# Staff Report

**Report To:** COW-Operations\_Planning\_and\_Development\_Services  
**Meeting Date:** June 11, 2024  
**Report Number:** CSOPS.24.043  
**Title:** 125 Peel Street Servicing Follow-up  
**Prepared by:** Mike Humphries, Senior Infrastructure Capital Project Coordinator

# PEEL ST. SOUTH ALTERNATIVE NO. 2: FULL URBANIZATION

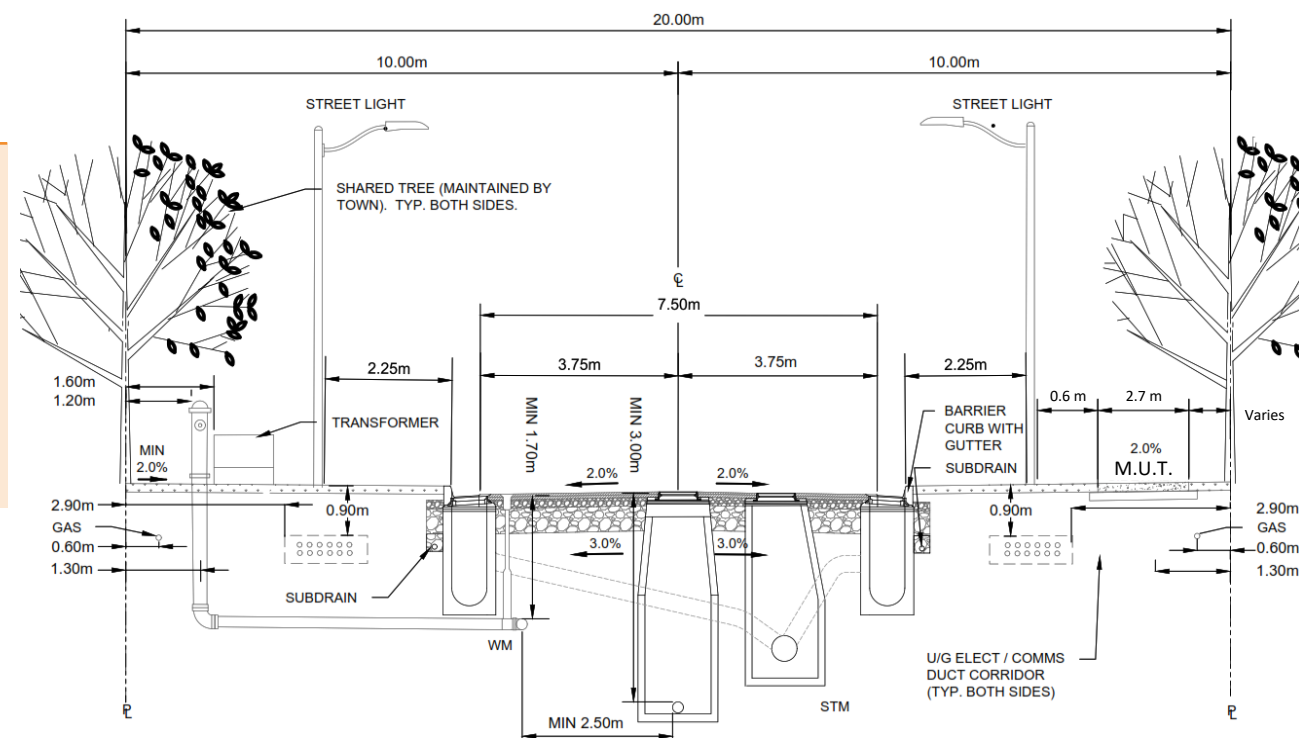
The community suggested that designers adopt a “minimalistic view” of what must be constructed. She indicated that the “Cross-section provided by Bill Abbotts” in his deputation, featuring an 8.5-meter road and fog lines at 1.25 meters, aligns with her idea of minimalism. This minimalistic option would not include a sidewalk for pedestrian safety or any works in the boulevards.

This option has been discussed previously and Staff still cannot support this. It is considered unsafe and unrealistic as outlined above in the analysis. The full 20m right-of-way is required for reconstruction and sidewalk and barrier curb must be provided for safety. Staff recommendations are unchanged from the original report to Committee of the Whole on April 30, 2024, CSOPS.24.018.

Considering the guiding documents, industry standards, and best practices, the recommended option is the Town Standard Urban Cross-section with barrier curb and gutter, featuring 7.5 meters of asphalt, and an in-boulevard multi-use trail along the west side of Peel St S. The multi-use trail will be designed to applicable Standards.

This multi-use trail will accommodate both cyclists and pedestrians, allowing for a narrower roadway asphalt width, which contributes to traffic calming. The 7.5-meter width is the minimum that the engineer is comfortable with, given that the road will function as a collector road with expected emergency and commercial vehicle traffic. Cyclists will use the in-boulevard multi-use trail, and the road will be posted as no parking.

The narrower road width will facilitate traffic calming, and the barrier curb and gutter will serve as a physical barrier to enhance pedestrian and cyclist safety. This configuration meets Town standards and provides maximum safety for all users. Additionally, the narrower road and multi-use trail offer some flexibility, potentially allowing for the retention of some trees, making this the preferred option.
